CITY OF ALBUQUERQUE

RE: 1998 Cherokee Rd NW

Grading and Drainage Plan Engineer's Stamp Date: 04/26/23

Hydrology File: F13D034

GD-1

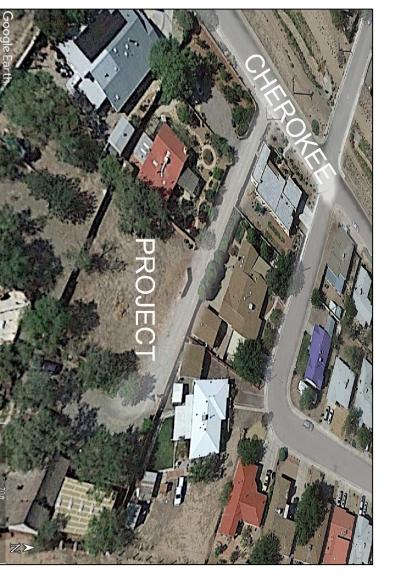
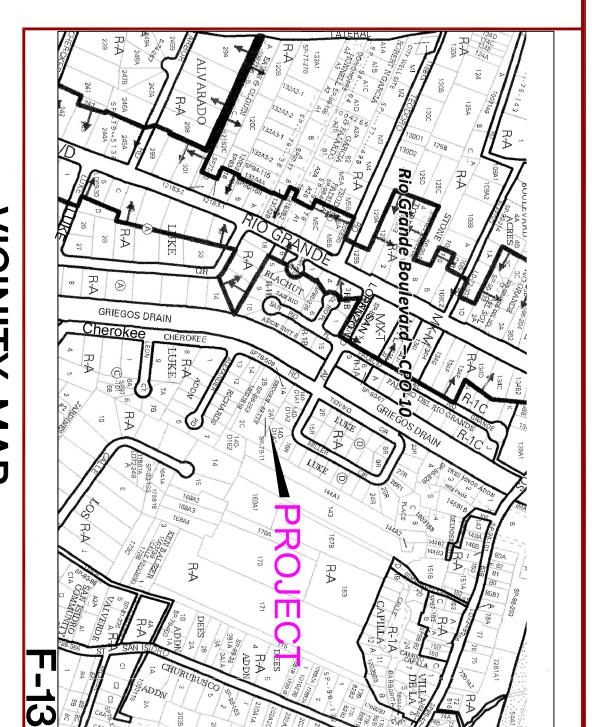
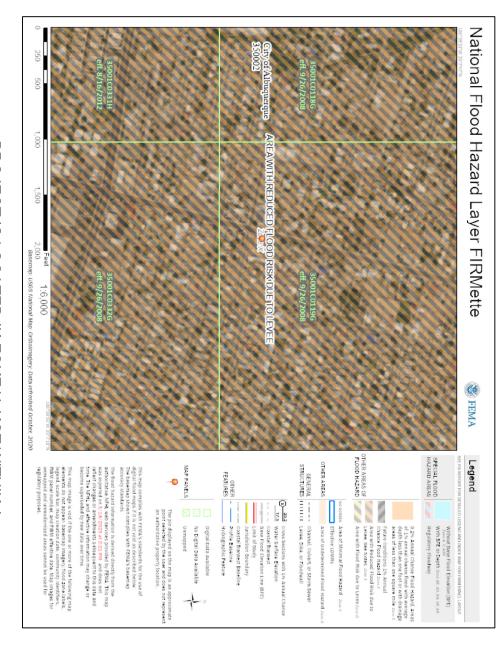
1. As stated, this site follows Article 6-5 Valley Drainage Criteria of the DPM and the required retention volume is 1675 CF. There are two retention ponds shown on the plans. One to the northeast of the proposed house that will provide 358 cubic feet of volume and one to the southwest of the proposed house that will provide 1500 cubic feet of volume. Based on my measurements, the southwest pond has a top of pond area of 628 square feet. With a typical 3 to 1 side slope and a depth of 1 foot, the bottom of pond area is about 148 square feet. The volume that can be obtained in this pond is only about 388 cubic feet. Combined with the first pond, the provided volume is only 746 cubic feet. This site is short 929 cubic feet of required retention volume. This may have to be placed in an underground storage system. There are may products on the market that can

be used. Please pick one and show that the required retention volume can be provided.
